Access Compliance Report

Public Rights-of-Way

(Curb Ramps)

Intersection ID: 48557	Main Street: RIDGEFOREST_DR	Cross Street: ARDREY_WOODS_DR	Location: NE
ADA ID: 341C096828E5	Ramp Type: BlendTrans1	Initial Pass/Fail: Fail	Overall Compliance: No
		Severity Score: 8.75

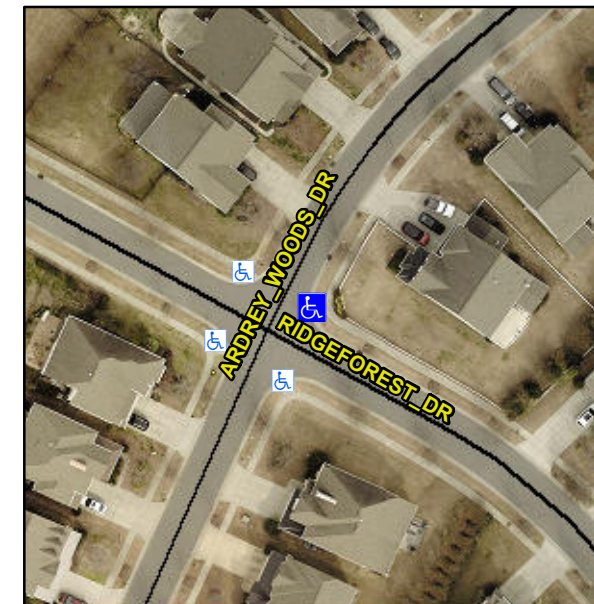
R304.5.1

Compliance	Description	Data	Compliance	Description	Data
N/A	Ramp Length (in)	71.0	Yes	BlendTrans Slope (%)	4.3
No	Ramp Width (in)	45.0	Yes	BlendTrans XSlope (%)	0.7
N/A	Flare Type LT	N/A	N/A	Flare Type RT	N/A
N/A	Flare Slope LT (%)	N/A	N/A	Flare Slope RT (%)	N/A
N/A	Flare Traversable LT?	N/A	N/A	Flare Traversable RT?	N/A
N/A	Landing Length (in)	N/A	N/A	DWS Provided?	N/A
N/A	Landing Width (in)	N/A	N/A	DWS Contrast?	N/A
N/A	Landing Slope (%)	N/A	N/A	DWS Length (in)	N/A
N/A	Landing X Slope (%)	N/A	N/A	DWS Full Width?	N/A
N/A	Landing Curb? (Y/N)	N/A	N/A	DWS Offset (in)	N/A
N/A	Shared Landing?	N/A			
N/A	Gutter Ponding?	N/A	N/A	Gutter Slope (%)	N/A
N/A	Gutter Lip Ht (in)	N/A	N/A	Gutter X Slope (%)	N/A
N/A	Painted X Walk1?	No	N/A	Painted X Walk2?	No
	X Walk 1 Direction	To NW		X Walk 2 Direction	To SW
	X Walk 1 Width (in)	N/A		X Walk 2 Width (in)	N/A
	X Walk 1 Slope (%)	3.5		X Walk 2 Slope (%)	1.1
	X Walk 1 X Slope (%)	0.6		X Walk 2 X Slope (%)	3.0

Remove & Replace Curb Ramp With Two New Directional Ramps or Equivalent.
